# Bridge Design Memorandum

**Re:** Replacing 9" Concrete Joint Beams With Keyed Construction Joints

SECTION E-E

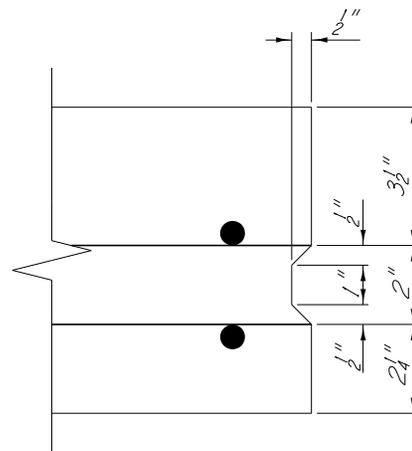
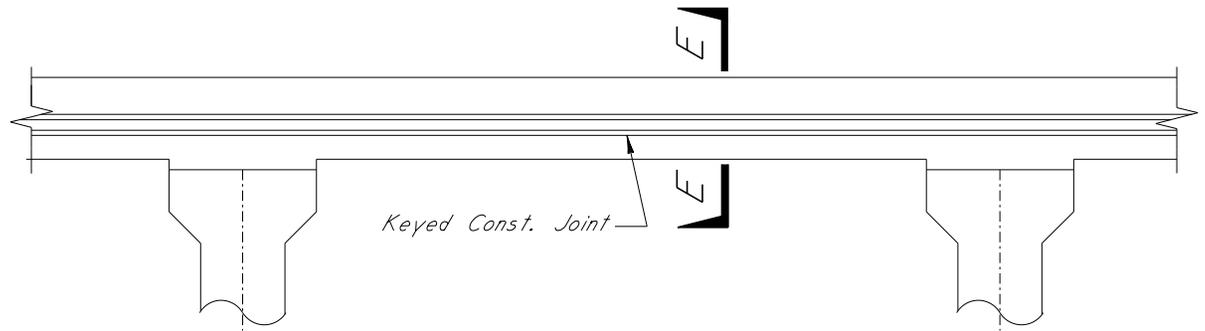
As per NJA and JMW, 9" concrete joint beams located at continuity pours in the bridge deck on all continuous prestressed girder bridges shall be replaced with keyed construction joints.

With MDOT's acceptance of contractor proposed VE's to change the pouring sequence to one (1) continuous pour, keyed construction joints provide a simple contingency to terminate pours. They also require less concrete and reinforcing.
